Addendum 15 – UN Regulation No. 16

Revision 9 - Amendment 1

Supplement 1 to the 07 series of amendments – Date of entry into force: 10 February 2018

Uniform provisions concerning the approval of:

Figure 2

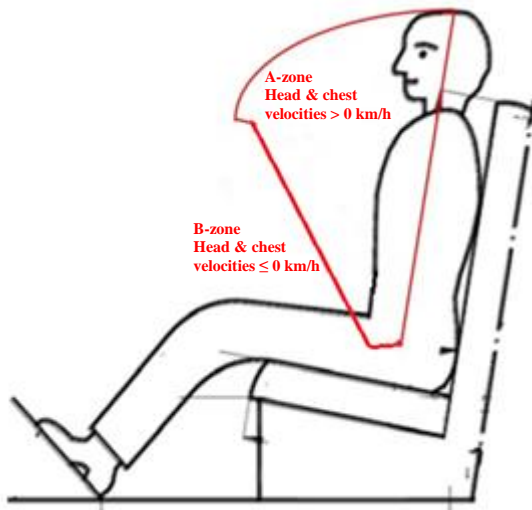
Insert a new item 12.1., to read:

"12.1. In case a restraint system has been granted/extended approval, those can be used for particular types of vehicles compatible with the following dimensional conditions: no interior part in a quoted A-zone as shown below (Figure 2):

"Figure 1
Specifications of the fixture (all dimensions in mm)

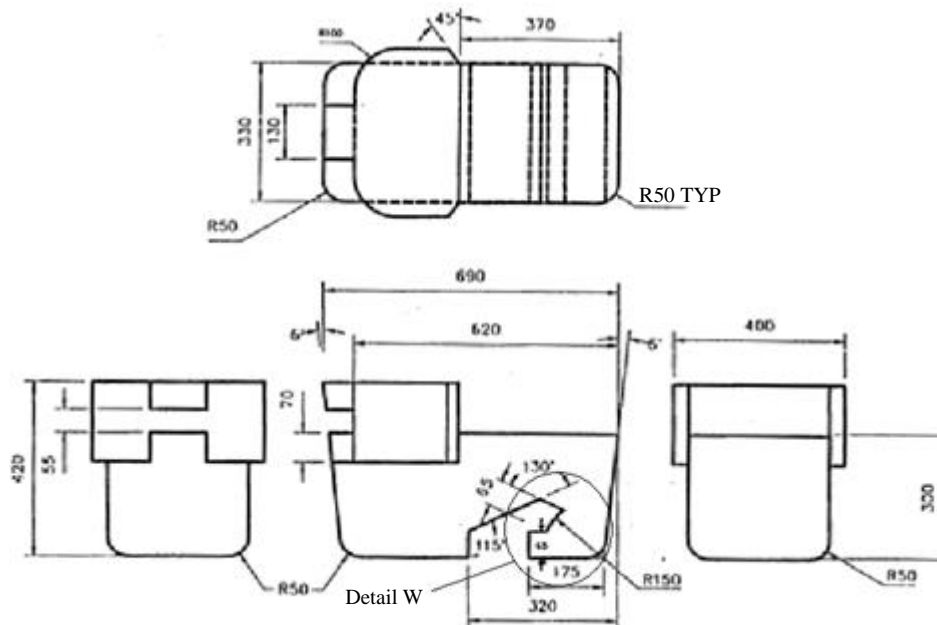
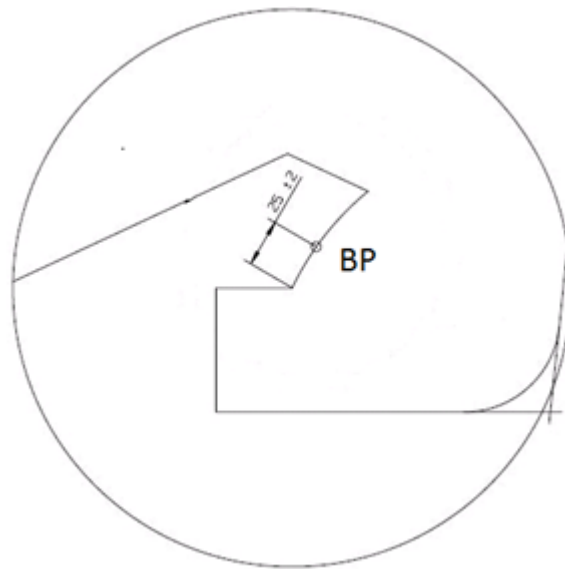
"3.2. The lap portion of the belt shall touch the fixture on both sides at the rear of the lap belt path (see Figure 3). The seat belt webbing shall always cover the points BP on the left and right ends of the curved edge; the exact position of point BP on the curved edge is indicated in detail W of Figure 1."

Figures 1 to 3, amend to read:

Figure 7

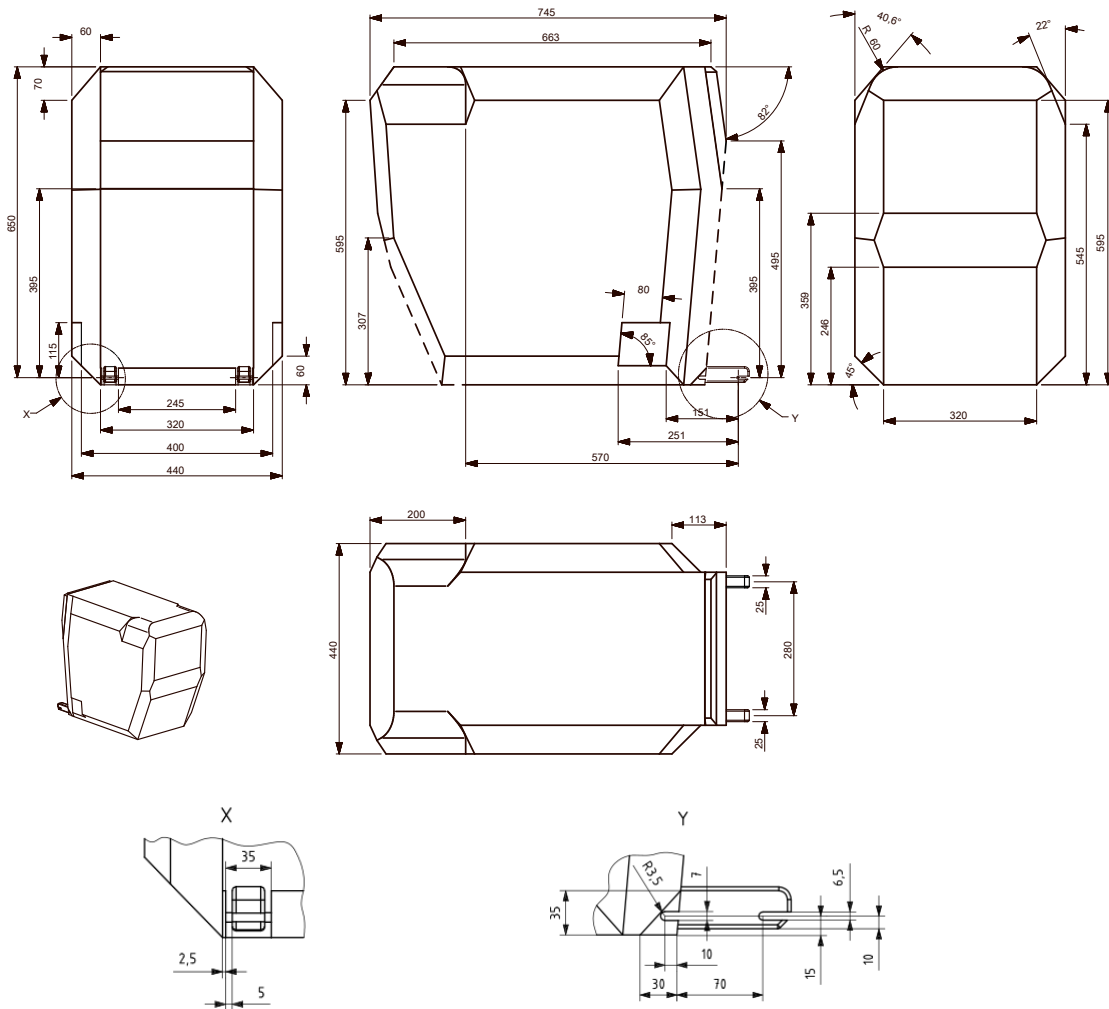
Appendix 2, insert a new paragraph 4.7. and a new Figure 7 to read:

"4.7. Rearward facing infant child restraint systems envelope ISO/R2X

Figure 8

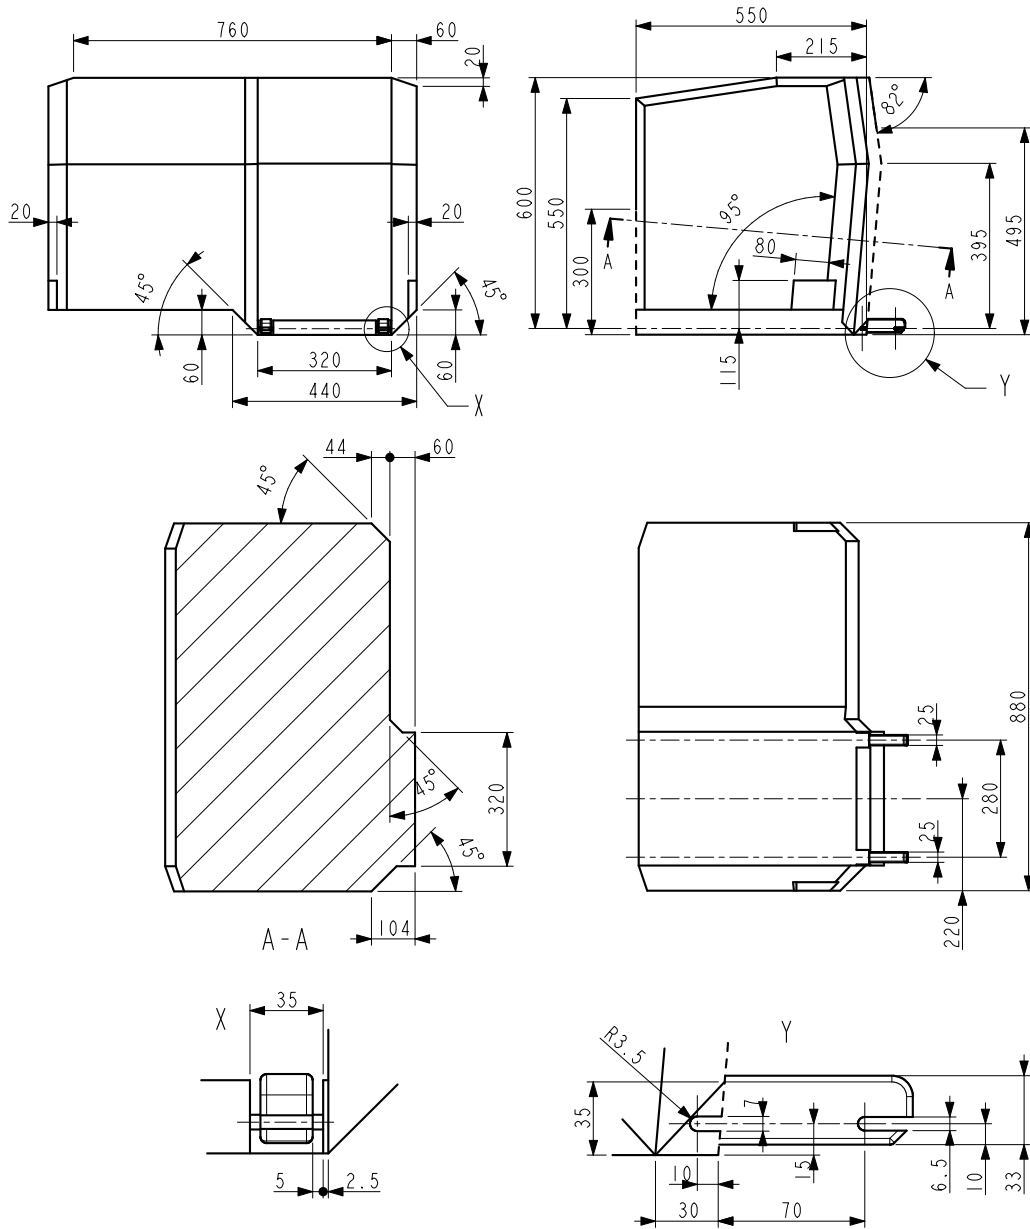
Appendix 2, paragraph 4.7 (former), renumber as paragraph 4.8. and amend to read:

"4.8. Lateral facing child restraint systems envelope

Figure 1
Positioning in Seat

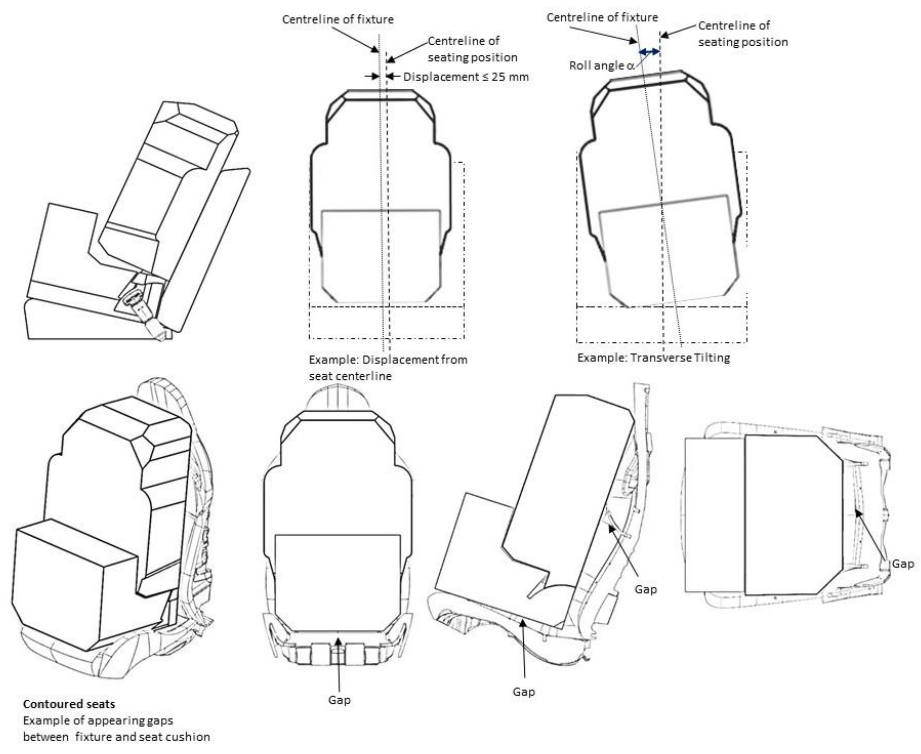
Insert a new Appendix 5 to read:

3. Requirements
 - 3.1. It shall be possible to secure the fixture in the seating position using the 3-point seat belt and to buckle up the seat belt.
 - 3.2. The roll angle α as shown in Figure 1 shall be equal to or less than 5° .

- 3.3. The base of the fixture shall be in contact with the seat cushion, and the back face of the fixture shall be in contact with the seat back or head restraint. Full contact with the seat is not necessary, "gaps" due to the vehicle seats contours are permitted as shown by the arrows in Figure 1. The booster seat envelope is equipped with an adjustable backrest. Compatibility with the vehicle seating position shall be achieved in at least one position of the backrest range shown in Figure 2 or Figure 3.

Figure 2
ISO/B2: Envelope dimensions for booster seat, reduced width 440 mm - without ISOFIX, or with connectors removed or stowed within the body of the fixture (behind line E, as defined by detail B)

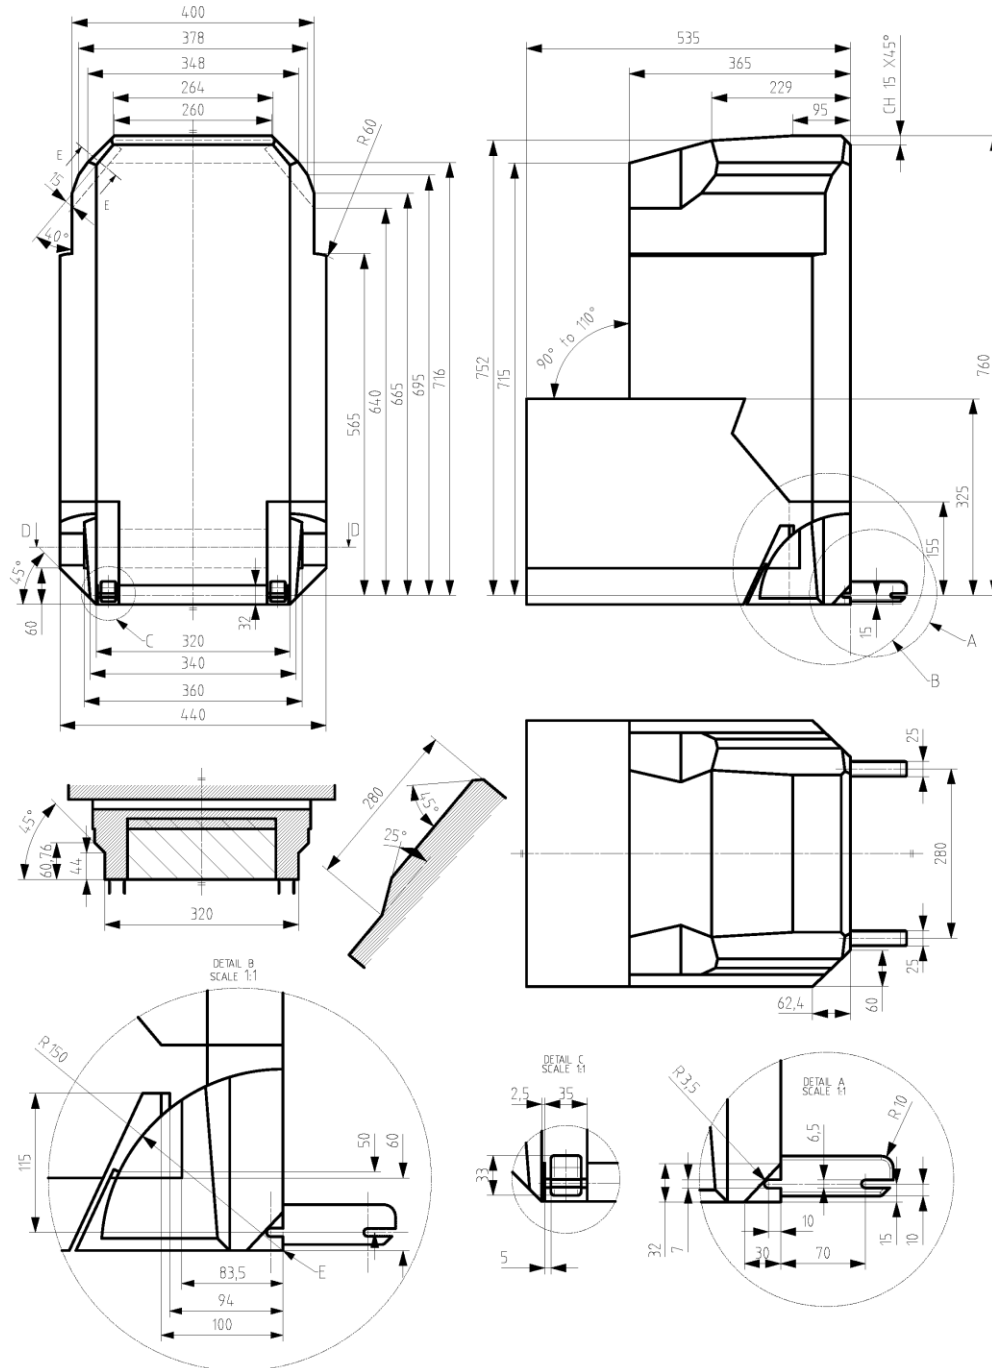
4. Booster seat child restraint system fixtures:
 - (a) ISO/B2: Booster seat, reduced width 440 mm (Figure 2)
 - (b) ISO/B3: booster seat, full width 520 mm (Figure 3)
